I. INTRODUCTION

DRAFT EIS COMMENT LETTERS

The City of Mount Vernon received five comment letters in response to the Draft EIS issued on November 1, 2006. Each letter has been assigned a reference number as shown below.

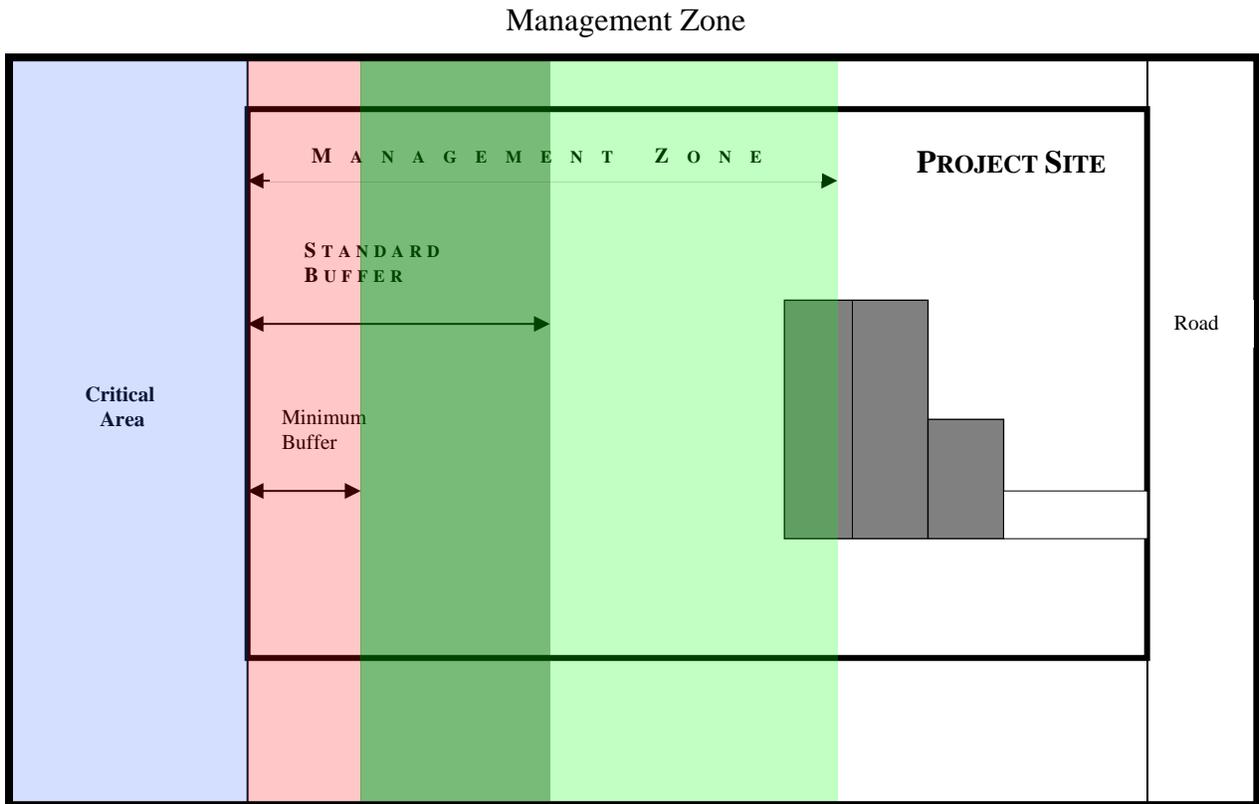
E. MANAGEMENT ZONE [2-14, 2-17]

The Management Zone is illustrated in Figure 4 of the DEIS, which is replicated below. The management zone is measured from the edge of a critical area and extends 200' upland. In the diagram below the 200 foot limit corresponds to the outer edge of the light green area. The management zone includes both the standard buffer and the minimum buffer widths.

The standard buffer width is measured from the critical area edge and includes the minimum buffer. In the diagram below the boundary of the standard buffer is depicted by the outer edge of the dark green area.

The minimum buffer is depicted by the red area in the diagram. The minimum buffer is intended to be a "no touch" area, below which no further alteration of the buffer is allowed.

Contributions to the Waters/Wetlands Reserve Program are triggered whenever there is a permit that will involve an increase in impervious surfaces or building footprint anywhere within the management zone. Contributions are assessed on a per square foot basis (see Section 15.40 120.D). Fees assessed within the area between the minimum and standard buffer width (shown as dark green on the diagram) are substantially higher than those assessed in the area between the standard buffer and the outer edge of the management zone (shown as light green on the

diagram). The higher fees reflect the higher cost of replacing actual buffer functions. In addition, any removal of tree canopy results in still higher assessed fees.

Note that the light green area is not part of the regulatory buffer. Even though alterations within this area of the management zone would not involve the buffer itself fees are still assessed. This is because BAS shows that many impacts can originate outside of the critical area and its associated buffer, particularly those related to stormwater.
